# Work Order ID 78421

Item Name: Crosstube Turning Detail

DRAWING NO. D212-664-247	TITLE CROSSTUBE ASS'Y (205 LOW AFT)	REV. B	<b>DART AEROSPACE LTD ENGINEERING ORDER</b>		D.E.O. NO. D212-664-247-B-1	SHEET NO. SHEET 1 OF 1	SCALE NTS
DRAWN <i>q</i>	CHECKED <i>ASS</i>	MFG. APPR. <i>AB</i>	APPROVED <i>MD</i>		DE APPR. <i>AB</i>		
DATE 11.07.15	DATE 11.07.20	DATE 11.07.21	DATE 11/07/21		DATE 11.07.21

REPLACE MAGNOBOND WITH PROSEAL.

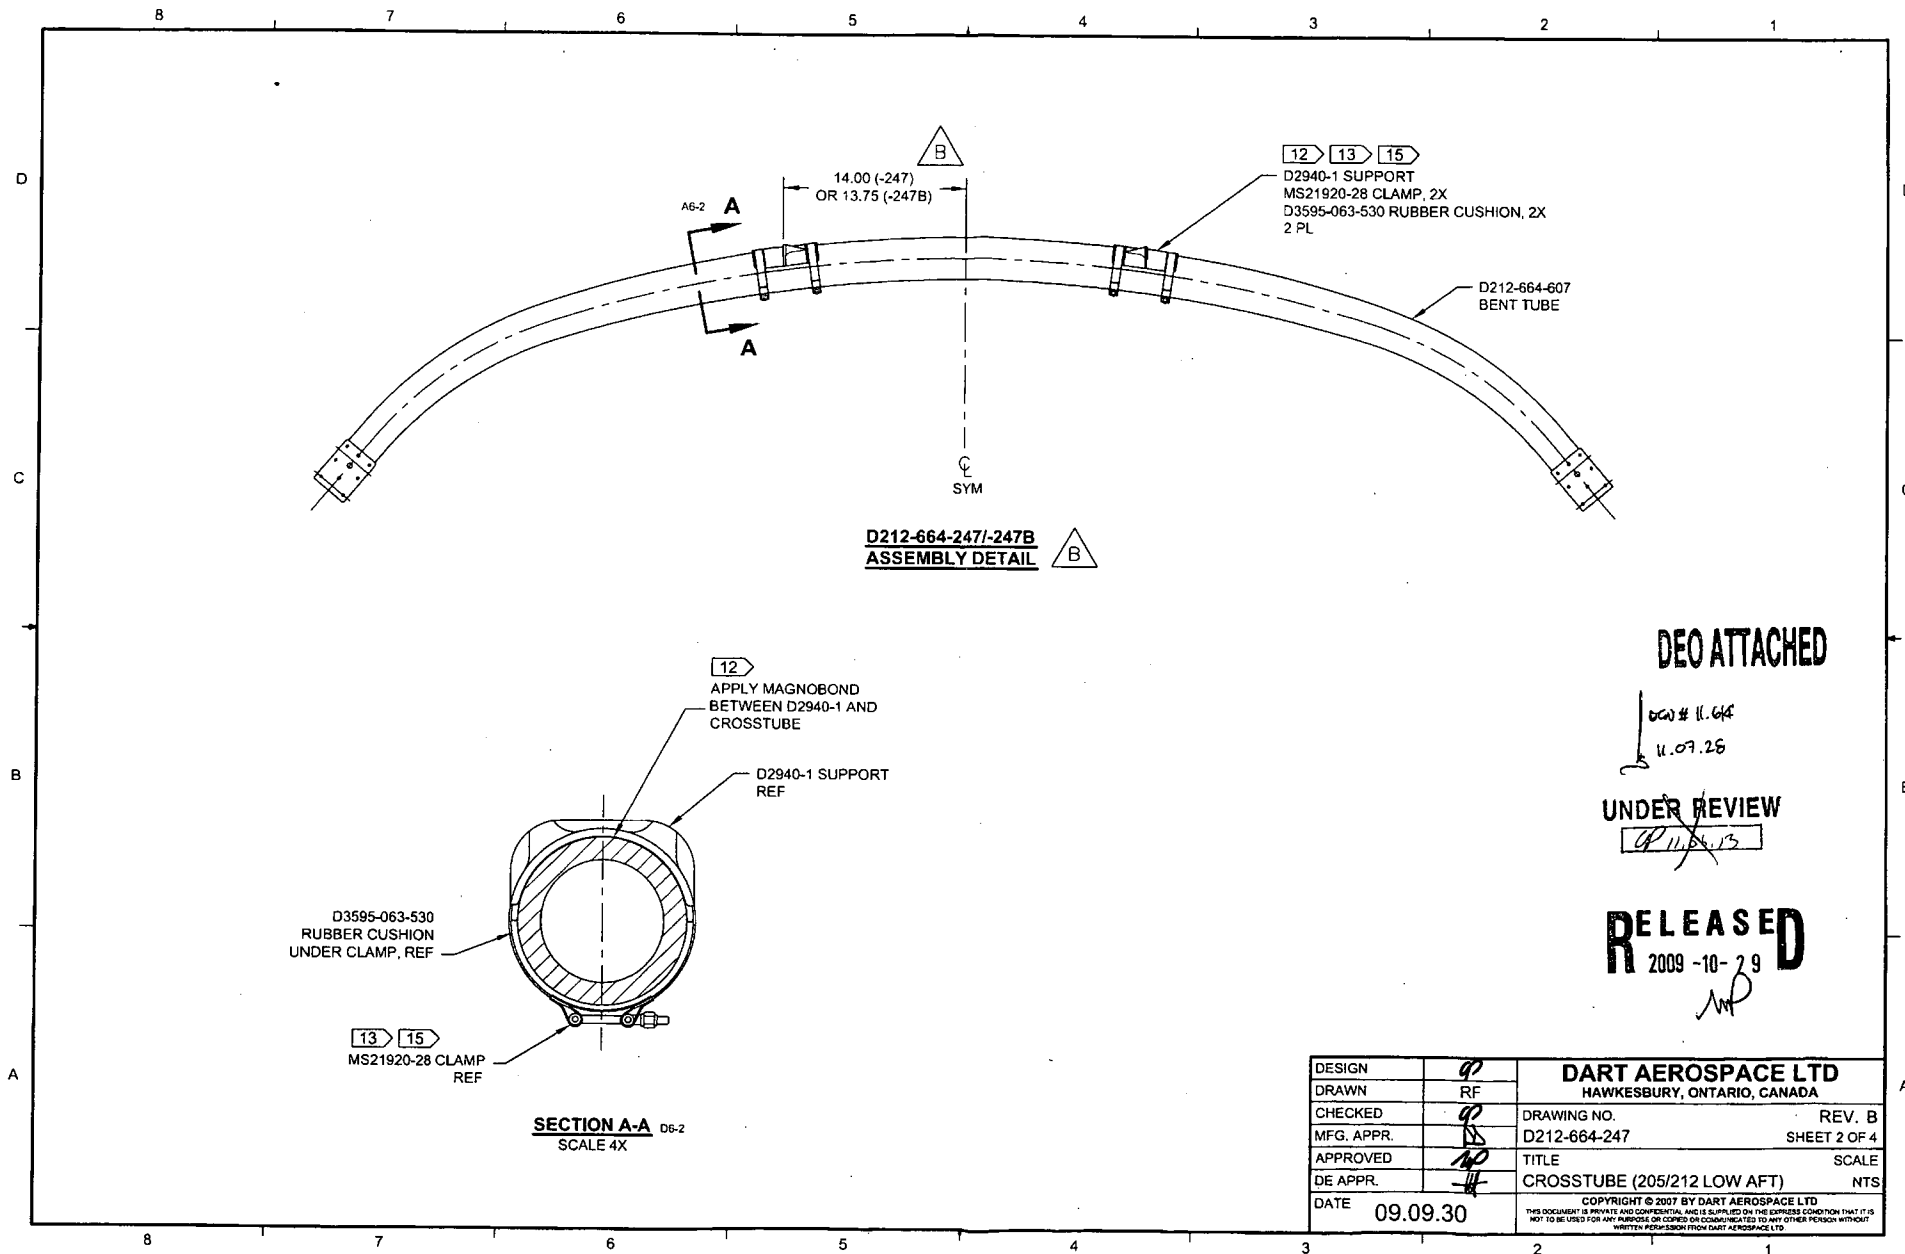
NOTE 12 & 15, SHEET 1 IS AMENDED AS FOLLOWS:

- 12) INSTALL D2940-1 SUPPORT USING 0.03" TO 0.06" THICK LAYER OF MAGNOBOND 6398 TO THE SURFACE OF D2940-1 THAT WILL BE IN CONTACT WITH THE CROSSTUBE PER QSI 015. LET CURE FOR 12 HOURS AFTER INSTALLATION AND PRIOR TO PACKAGING.
- 15) TORQUE CLAMPS 80 TO 100 IN-LB. ENSURE AT LEAST 1.5 THREADS SHOWING IN SAFETY AND THAT NUT HAS NOT BOTTOMED-OUT AFTER TORQUING.

Item	Qty -247	Qty -247B	Part Number	Description
9	A/R	A/R	PROSEAL 890 B-2	SEALANT, AMS-S-8802 CLASS B-2

- 12) TO INSTALL D2940-1 SUPPORT: ABRASE MATING SURFACE OF SUPPORT AND CROSSTUBE WITH 180-GRIT SANDPAPER AND REMOVE RESIDUE WITH MEK (OR EQUIVALENT). APPLY A 0.04" TO 0.07" THICK LAYER OF PROSEAL 890 CLASS B-2 (OR AMS-S-8802 CLASS B-2) SEALANT TO MATING SURFACE OF SUPPORT.
- 15) TORQUE CLAMPS 80 TO 100 IN-LB. ENSURE AT LEAST 1.5 THREADS SHOWING IN SAFETY AND THAT NUT HAS NOT BOTTOMED-OUT AFTER TORQUING. **PRIOR TO PACKAGING, RE-CHECK TORQUE ON CLAMPS AFTER PROSEAL 890 SEALANT HAS CURED FOR 72 HOURS.**
